Access Compliance Report

Intersection ID: 48643	Main Street: SOCATA_WY	Cross Street: BROCK_RN	Location: SE
ADA ID: 343413CE0856	Ramp Type: PerpDiag	Initial Pass/Fail: Pass	Overall Compliance: No
		Severity Score: 6.25

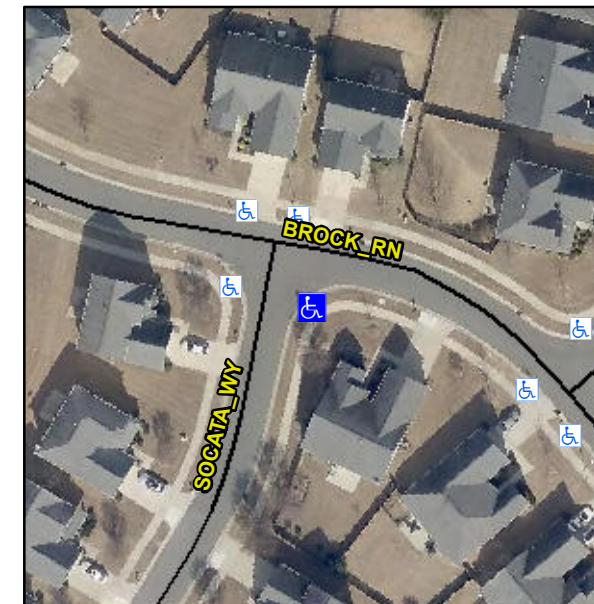
Compliance	Description	Data	Compliance	Description	Data
N/A	Ramp Length (in)	72.0	Yes	Ramp Slope (%)	7.2
No	Ramp Width (in)	46.0	Yes	Ramp XSlope (%)	0.5
N/A	Flare Type LT	Sloped	N/A	Flare Type RT	N/A
N/A	Flare Slope LT (%)	6.1	Yes	Flare Slope RT (%)	2.6
N/A	Flare Traversable LT?	Yes	N/A	Flare Traversable RT?	Yes
Yes	Landing Length (in)	59.5	Yes	DWS Provided?	Yes
Yes	Landing Width (in)	58.0	Yes	DWS Contrast?	Yes
No	Landing Slope (%)	2.2	Yes	DWS Length (in)	25.5
Yes	Landing X Slope (%)	1.3	Yes	DWS Full Width?	Yes
N/A	Landing Curb? (Y/N)	No	Yes	DWS Offset (in)	1.0
N/A	Shared Landing?	No			
Yes	Gutter Ponding?	No	No	Gutter Slope (%)	6.3
Yes	Gutter Lip Ht (in)	0.0	Yes	Gutter X Slope (%)	1.3
N/A	Painted X Walk1?	No	N/A	Painted X Walk2?	No
	X Walk 1 Direction	To NE		X Walk 2 Direction	To NW
N/A	X Walk 1 Width (in)	N/A	N/A	X Walk 2 Width (in)	N/A
	X Walk 1 Slope (%)	2.8		X Walk 2 Slope (%)	1.6
	X Walk 1 X Slope (%)	2.0		X Walk 2 X Slope (%)	2.6

Remove & Replace Curb Ramp With Two New Directional Ramps or Equivalent. Remove & Replace Gutter.

R304.5.1, R304.2.2-Perp, R304.3.2-Para, R304.5.4
